Development Services Staff Report for Design Review Committee

To: Design Review Committee
From: DS Staff: Erika Akin
Subject: Proposed Addition to J's Car Wash
File: DSRFY2016-1
Date: January 19, 2016

Summary: *J's Car Wash*, represented by Josh Howa of Howa Design, is proposing to expand the current vehicle washing facility at 3756 West Chinden. The proposal requires Design Review Committee approval to add a traffic/stacking lane onsite, modify existing landscaping, add a vehicle access to Chinden Blvd., remove fencing, add on to the existing building and redesign the site. The applicant is proposing the addition of landscape areas to adjacent properties through the removal of asphalt along the existing Chinden sidewalks. The DR application includes site design, landscaping plan, building elevations and schematics. The project is zoned C-1 General Commercial and Mixed Use Commercial and Green Boulevard Corridor Comprehensive Plan designation.

sheet number:
L1.0

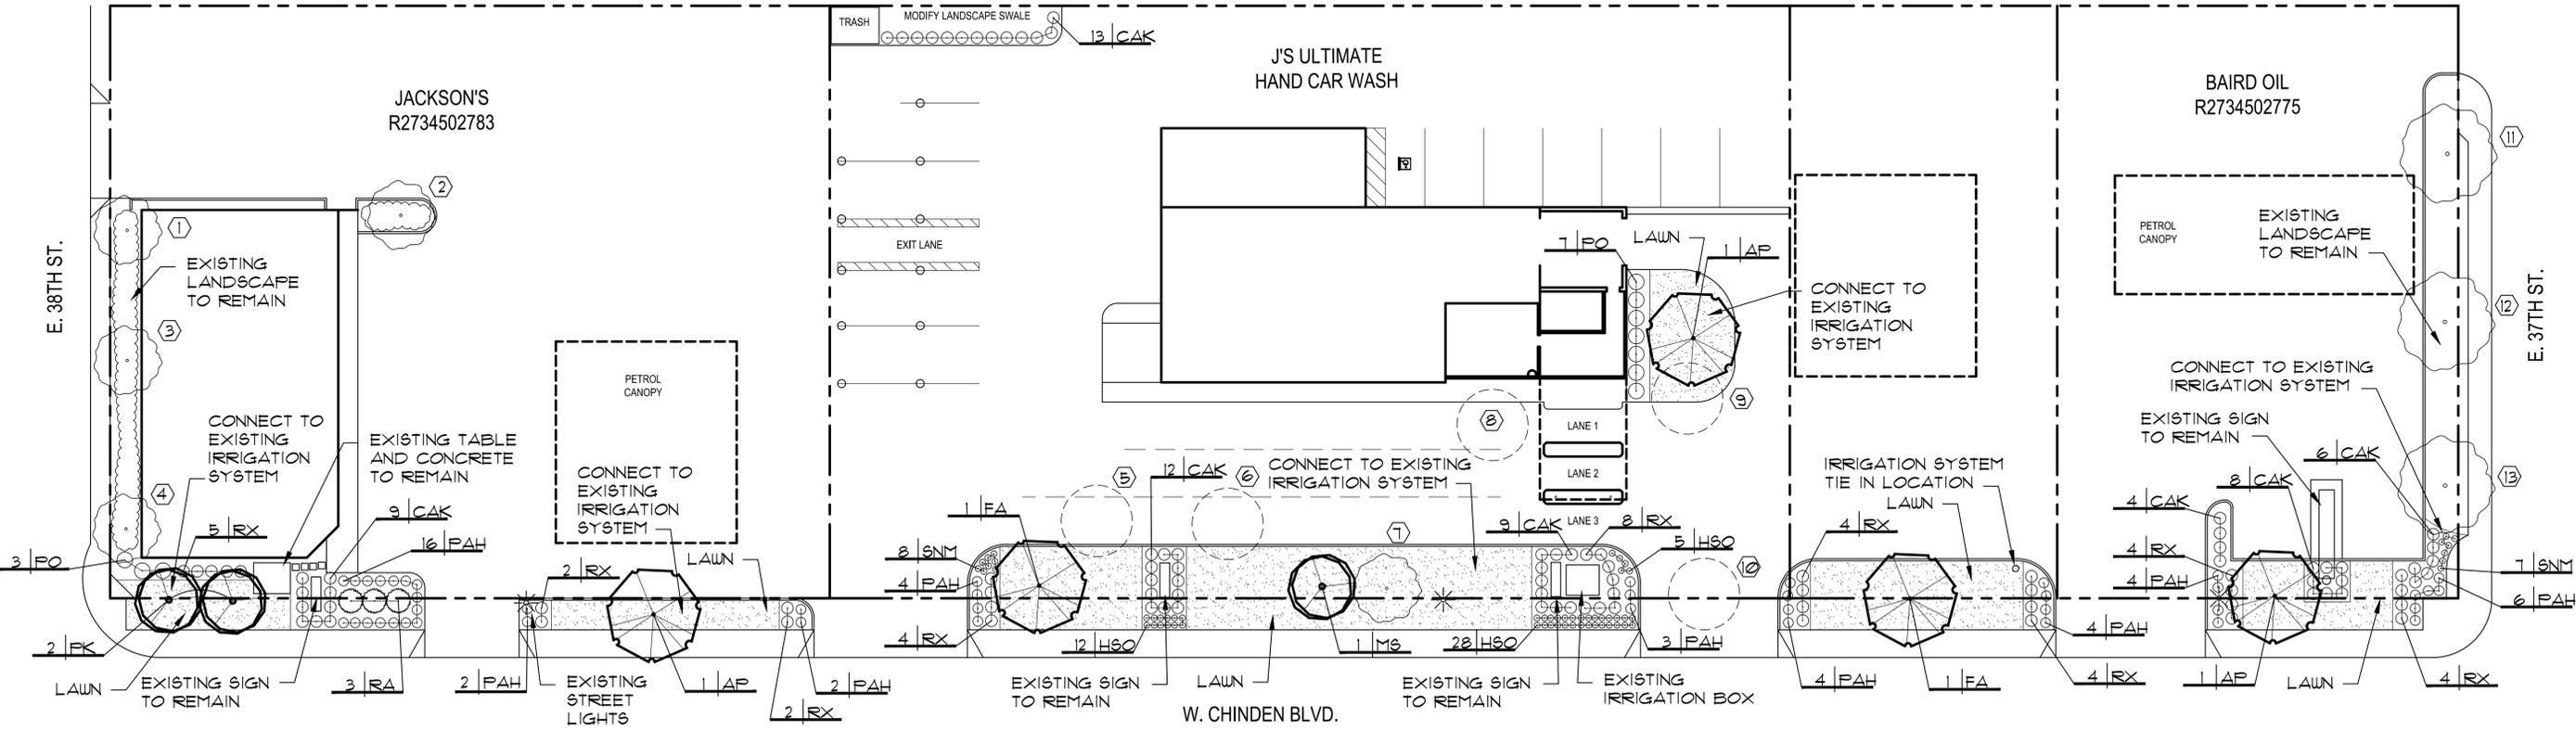
- Adding a Chinden Boulevard access violates Code; Consider escape route to Osage instead of Chinden
- Tree mitigation for removal of five existing trees onsite not provided.
- Stacking lane may not be screened as required in Drive Through provisions
- A safe pedestrian route for customers to and from their vehicle to the waiting areas has not been identified on the plans
- Existing drainage swale modification and onsite drainage retention may be difficult
- Street trees added to adjacent properties improve entire block of streetscape
- Will adjacent property owners allow landscaping beds to be reworked? Are agreements in place to allow the installation?
- Who will maintain new landscaping?
- How will the new detail parking places be accessed?
- Cross access agreements (cars exit from J's onto Jacksons property)
